Access Compliance Report

Public Rights-of-Way

Intersection ID: 17169	Main Street: IDLEWILD_RD	Cross Street: CEDARS_EAST_CT	Location: SE
ADA ID: 4D731A535DBB	Ramp Type: Perp	Initial Pass/Fail: Fail	Overall Compliance: No
		Severity Score: 12.5

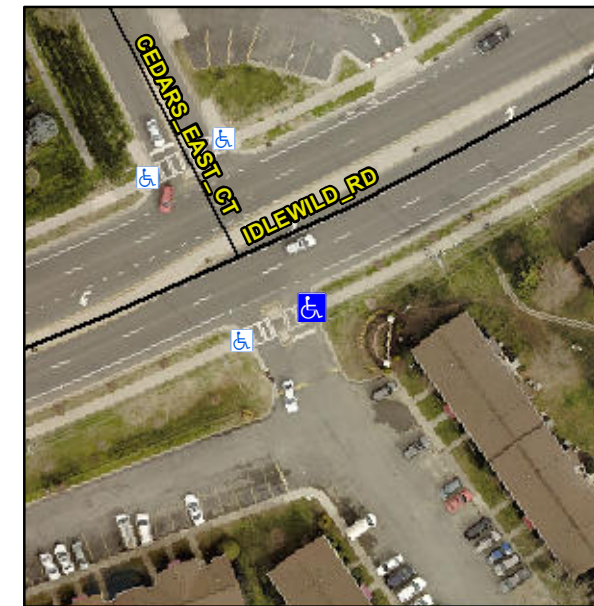
Not Found, R304.2.2

Compliance	Description	Data	Compliance	Description	Data
N/A	Ramp Length (in)	77.0	No	Ramp Slope (%)	8.5
Yes	Ramp Width (in)	48.0	Yes	Ramp XSlope (%)	1.2
N/A	Flare Type LT	N/A	N/A	Flare Type RT	N/A
N/A	Flare Slope LT (%)	N/A	N/A	Flare Slope RT (%)	N/A
N/A	Flare Traversable LT?	N/A	N/A	Flare Traversable RT?	N/A
N/A	Landing Length (in)	N/A	N/A	DWS Provided?	N/A
N/A	Landing Width (in)	N/A	N/A	DWS Contrast?	N/A
N/A	Landing Slope (%)	N/A	N/A	DWS Length (in)	N/A
N/A	Landing X Slope (%)	N/A	N/A	DWS Full Width?	N/A
N/A	Landing Curb? (Y/N)	N/A	N/A	DWS Offset (in)	N/A
N/A	Shared Landing?	N/A			
N/A	Gutter Ponding?	N/A	N/A	Gutter Slope (%)	N/A
N/A	Gutter Lip Ht (in)	N/A	N/A	Gutter X Slope (%)	N/A
N/A	Painted X Walk1?	Yes	N/A	Painted X Walk2?	N/A
	X Walk 1 Direction	To W		X Walk 2 Direction	N/A
N/A	X Walk 1 Width (in)	111.0	N/A	X Walk 2 Width (in)	N/A
	X Walk 1 Slope (%)	0.0		X Walk 2 Slope (%)	N/A
	X Walk 1 X Slope (%)	0.8		X Walk 2 X Slope (%)	N/A

Remove & Replace Entire Ramp.
